SUBJECT: NRC REVIEW OF IDAHO NUCLEAR TECHNOLOGY AND ENGINEERING
CENTER DRAFT WASTE-INCIDENTAL-TO-REPROCESSING DETERMINATION
FOR TANK FARM FACILITY RESIDUALS - CONCLUSIONS AND
RECOMMENDATIONS

U. S. NUCLEAR REGULATORY COMMISSION
REVIEW OF IDAHO NUCLEAR TECHNOLOGY AND ENGINEERING CENTER
DRAFT WASTE-INCIDENTAL-TO-REPROCESSING DETERMINATION FOR
TANK FARM FACILITY RESIDUALS

Figure 4. Illustration of the two-dimensional modeling slice used in PORFLOW

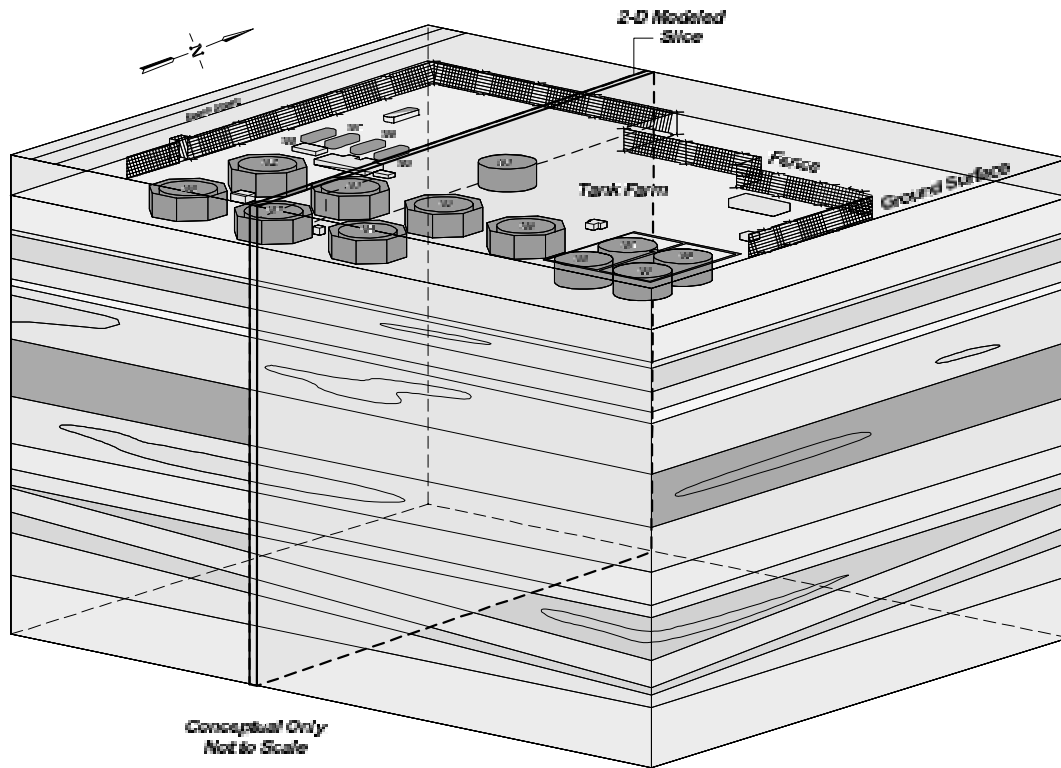
The overall modeling approach appears to be a reasonable attempt to manage uncertain hydrologic and geologic information. It appears, in general, that DOE-ID appropriately assessed the TFF transport system through use of conservative assumptions. These conservative assumptions help to simplify the transport model as well as add confidence in the output. Conceptual model uncertainty can, in some cases, significantly impact the risk when transport is through a fractured, unsaturated hydrologic system. Confidence is gained with the DOE-ID approach as a result of the comparisons of the model predictions for tritium movement with the observations [36].
